## ZLIN AIRCRAFT a.s.

## MANDATORY SERVICE BULLETIN Z 242L/17a

Z 242L aircraft S/No. 065l through S/No. 0676.

2. SUBJECT: When handling the auxiliary tank cap, the wire lockring on the auxiliary tank filler flap can loosen.

Fig. 1. : THE AUXILIARY TANK FILLER FLAP

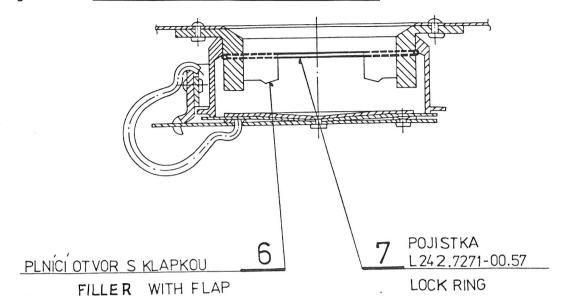
3.1 Check the correct position of the lock ring in the groove of the auxiliary tank filler flange.

8.1 Check by touch or visually with the mirror whether the lock ring (Item 7 - See Fig. 1) is properly positioned in the groove of the auxiliary tank filler frange (Item 6). If the lock ring is not properly sitting in the groove, reset it.

Fig. 2.: AUXILIARY TANK CAP

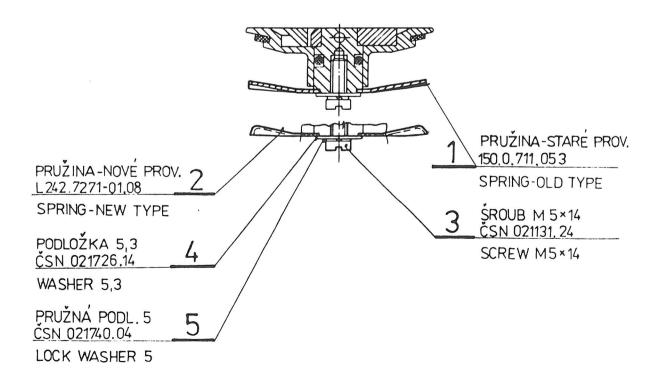
3.2 Replace the auxiliary tank cap springs.

8.2 Remove the closure spring (Item 1, P/N 150.0.711.053) and replace it by the new one (Item 2, P/N L 242.7271-01.08). The screw M 5x14, Item 3, is secured in the threads by the bonding agent - LOCTITE (ALDURIT). It is recommended to preheat the screw (Item 3) by applying the electric soldering iron to the screw head because of easier removal. At reassembly of Items 3, 4, 5, secure the screw (Item 3) by application of the above-mentioned bonding agent to the screw threads.
